BUREAU OF LAND MANAGEMENT	APR 1 5 5) ibease Senal No			
SUNDRY NOTICES AND REPORTS O	N WELLS			
Do not use this form for proposals to drill or abandoned well. Use Form 3160-3 (APD) for s	to re-enter an OCD A HTES!A Notice or Tribe Name			
SUBMIT IN TRIPLICATE- Other instructions of	7. If Unit or CA/Agreement, Name and/or No Poker Lake Unit NMNM71016X			
I Type of Well ☐ ☐ Gas Well ☐ ☐ Other	8 Well Name and No.

2. Name of Operator BOPCO, L. P.	Poker Lake Unit 319H  9 API Well No			
3a. Address       3b. Phone N         P. O. Box 2760 Midland, TX 79702       432-683-7	o. (include area code) 30-015-39834 2277 10. Field and Pool, or Exploratory Area			
4 Location of Well (Footage, Sec., T., R., M., or Survey Description)	WILDCAT; DELAWARE			
SHL: NESE, UL I, 2200' FSL, 1220' FEL, Sec 4, T24S-R30E, Lat:N32.24' BHL: 1415' FSL, 600' FEL, Sec 10, T24S-R30E, Lat:N32.228856,Long:W

#### Poker Lake Unit 319H BOPCO, L.P. 30-015-39834 Conditions of Approval

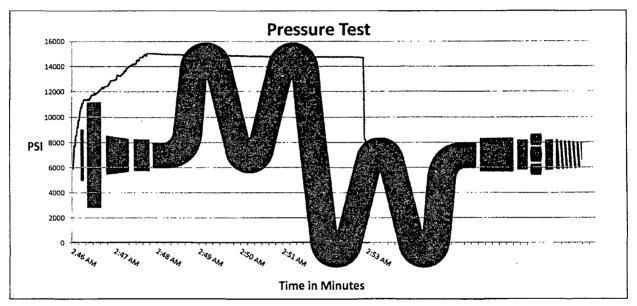
- 2. Variance approved to use flex line from BOP to choke manifold. Check condition of flexible line from BOP to choke manifold, replace if exterior is damaged or if line fails test. Line to be as straight as possible with no hard bends and is to be anchored according to Manufacturer's requirements. The flexible hose can be exchanged with a hose of equal size and equal or greater pressure rating. Anchor requirements, specification sheet and hydrostatic pressure test certification matching the hose in service, to be onsite for review. If the BLM inspector questions the straightness of the hose, a BLM engineer will be contacted and will review in the field or via picture supplied by inspector to determine if changes are required (operator shall expect delays if this occurs).

The recommendation for anchoring this assembly is to attach a safety clamp on the mid-section of the hose and anchor to the sub-floor on the rig.
